August 2, 1985
ST-HL-AE-1316
File No.: G4.2

South Texas Project
Units 1 & 2
Docket Nos. STN 50-498, STN 50-499
Meeting Notes from NRC MEB Audit
ASME Documentation Review Portion

- Attachments:
- A. Summary of Results
 - B. Requested Documents
 - C. List of Attendees

Fig. 32 Locations of Pipe Runs
and Pres. Forces (in kips)
(Part 1)

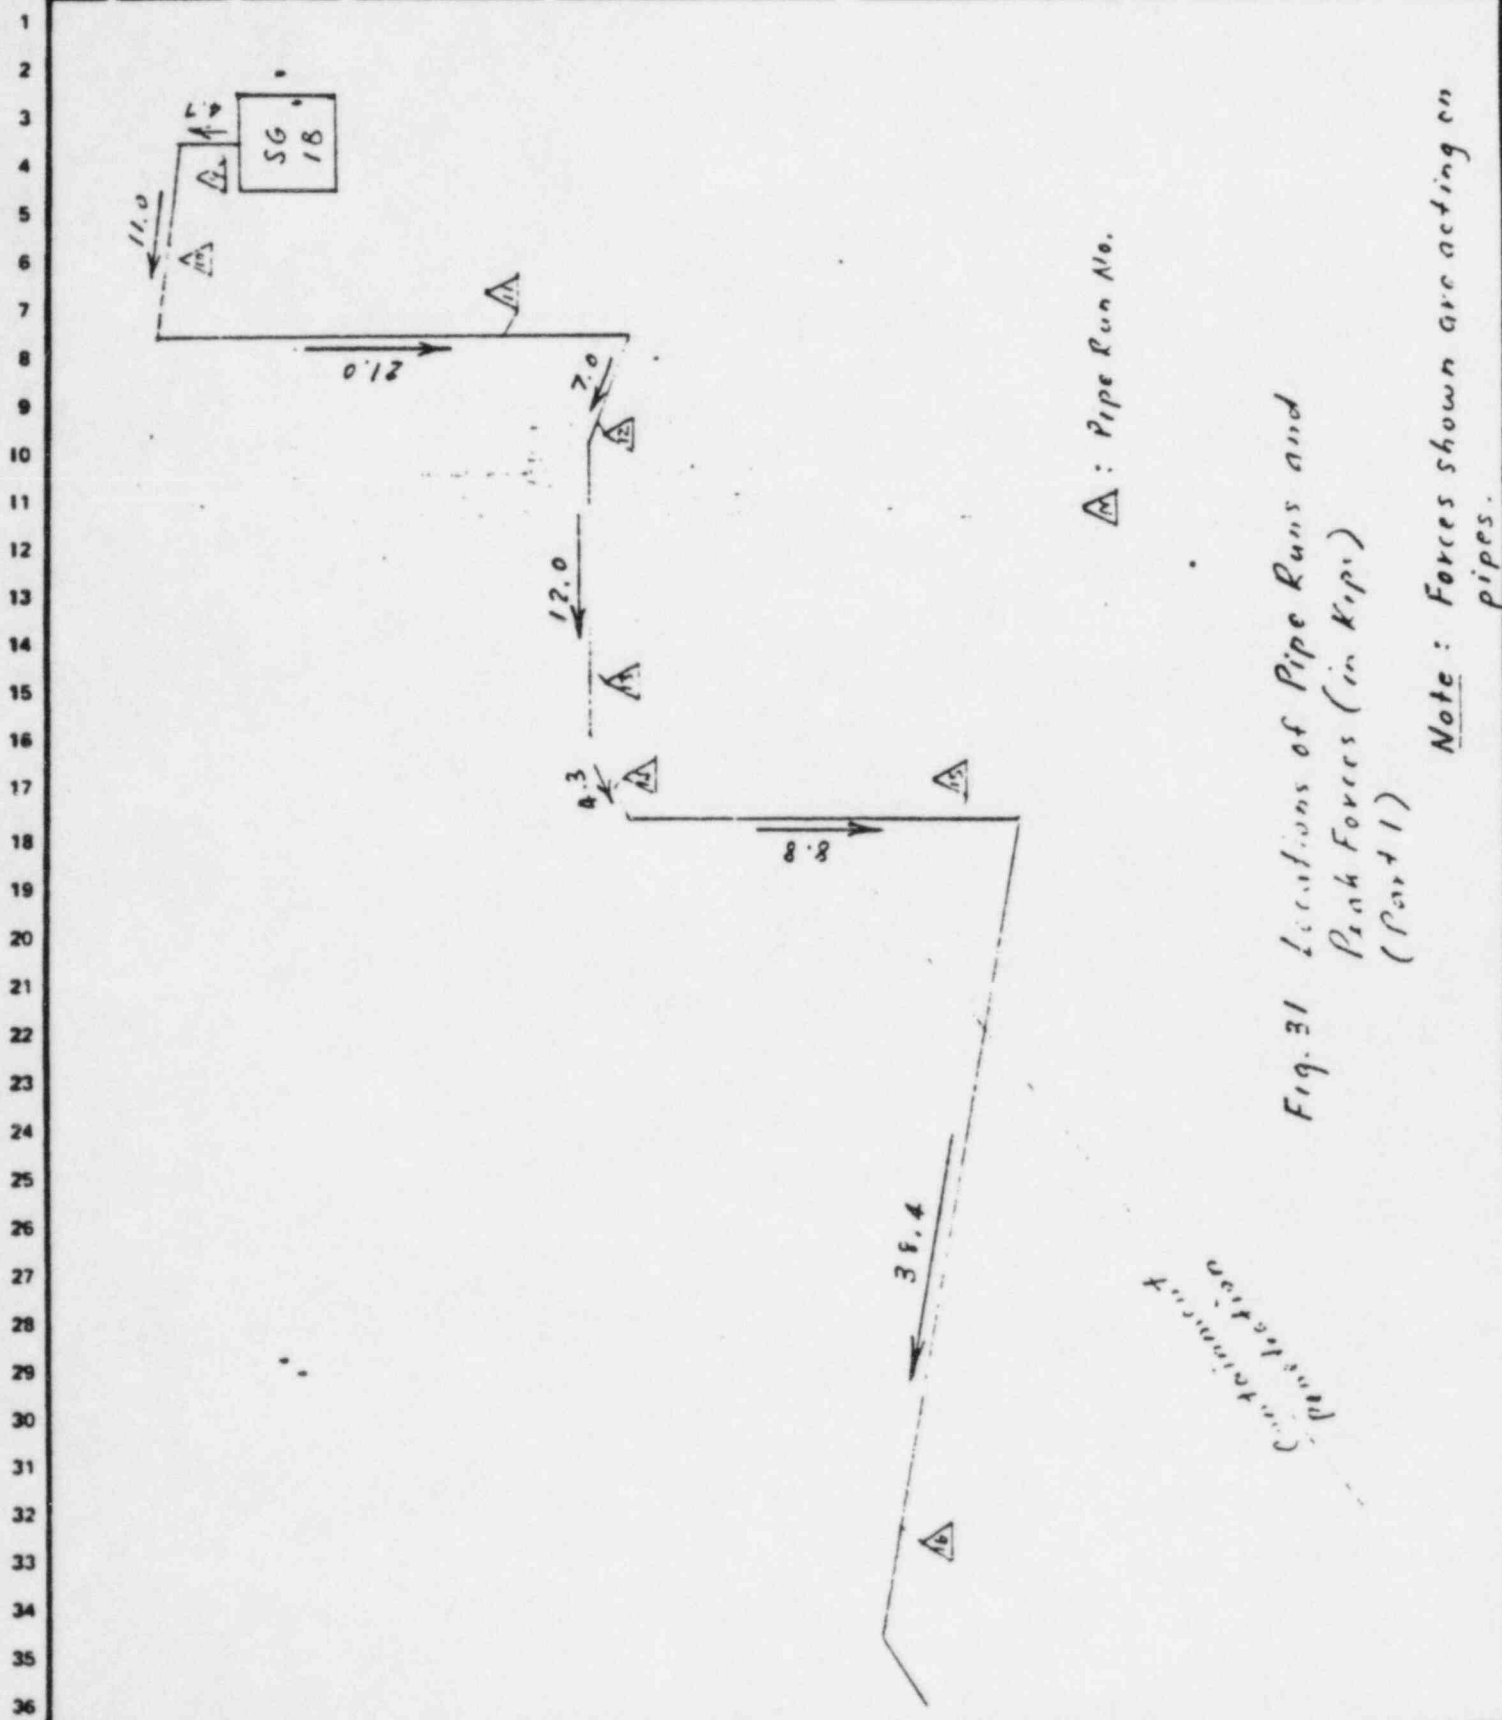
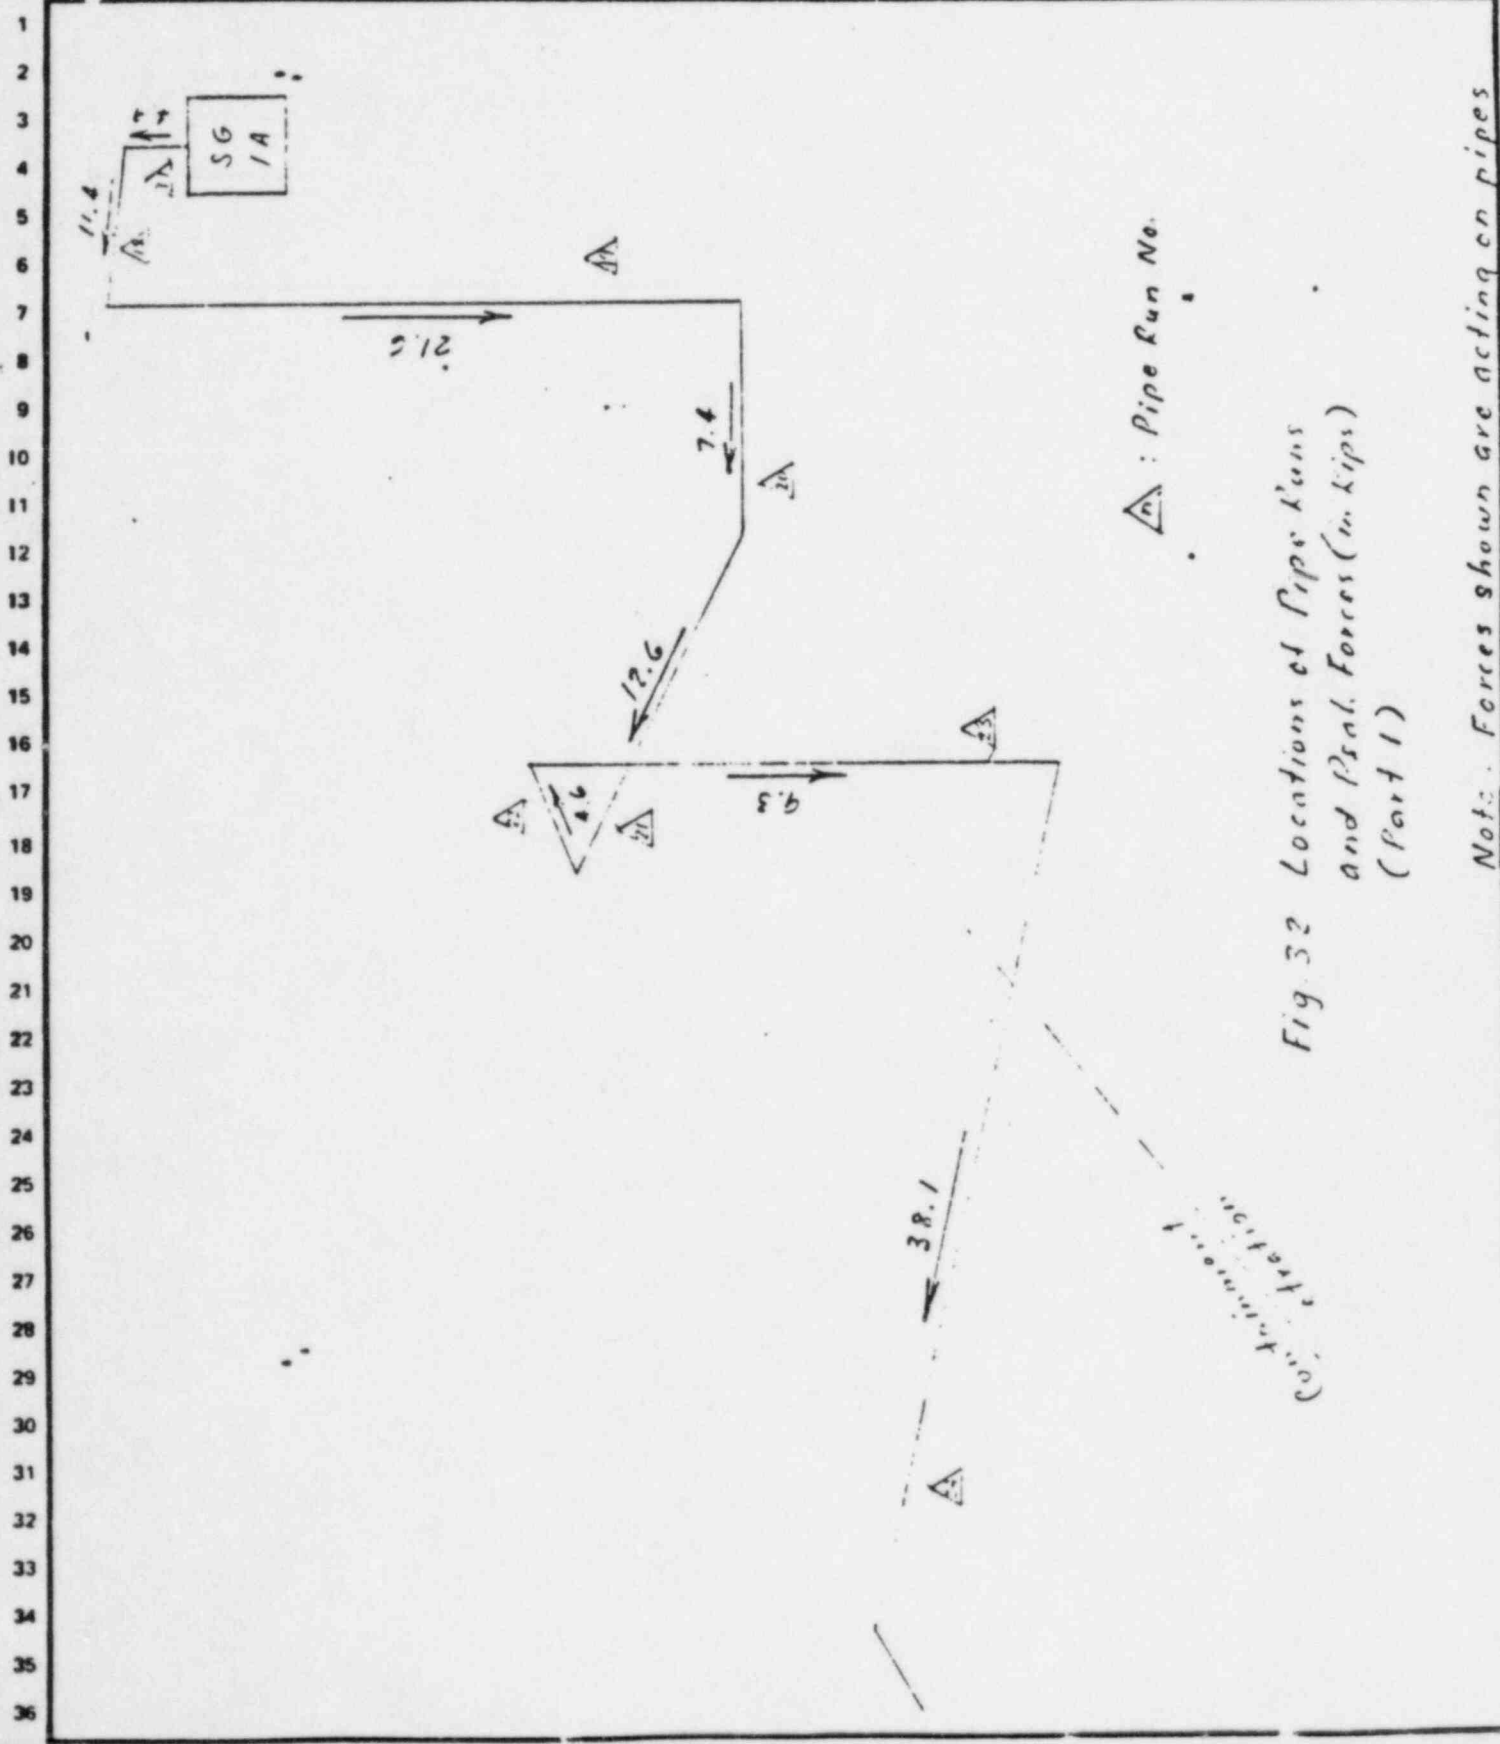
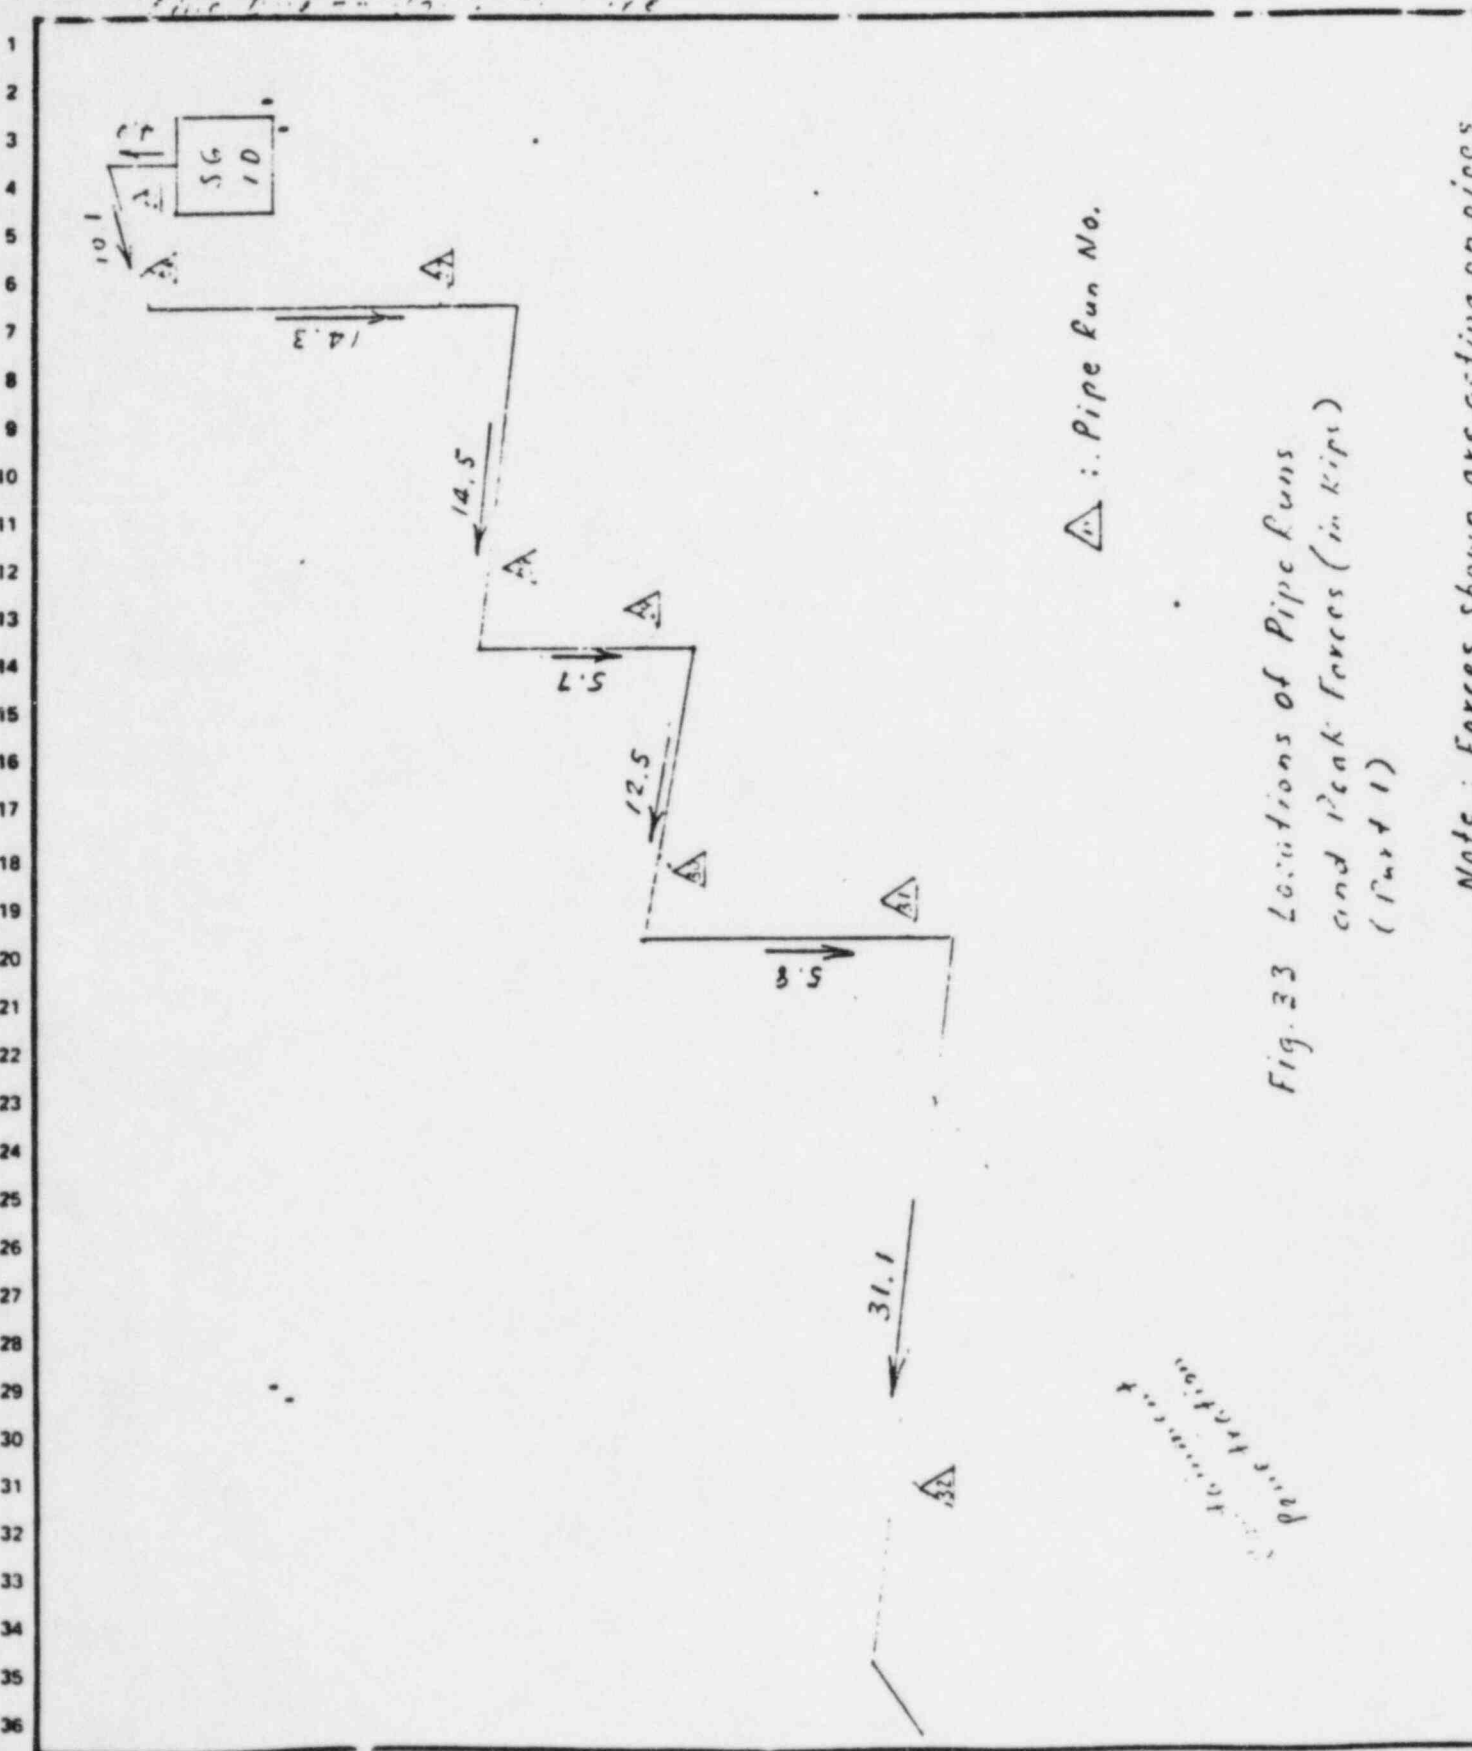
- (a) Does the 1183 psi operating pressure include the pressure wave due to the steam hammer?
- (b) Please describe the steam hammer analysis; e.g., source (turbine trip?), maximum moments and their locations, maximum pressures, support loads. (This may be given in Calculation No. 5N179RC9904; if so, please provide a copy of it.)

- 2. In response to Item (a), it was stated that the 1183 psi operating pressure does not include the pressure wave due to steam hammer.

In response to Item (b), a copy of Calculation No. 5N179RC9904 without appendices was provided. A hand calculation showing the maximum pressure caused by steam hammer was also provided.
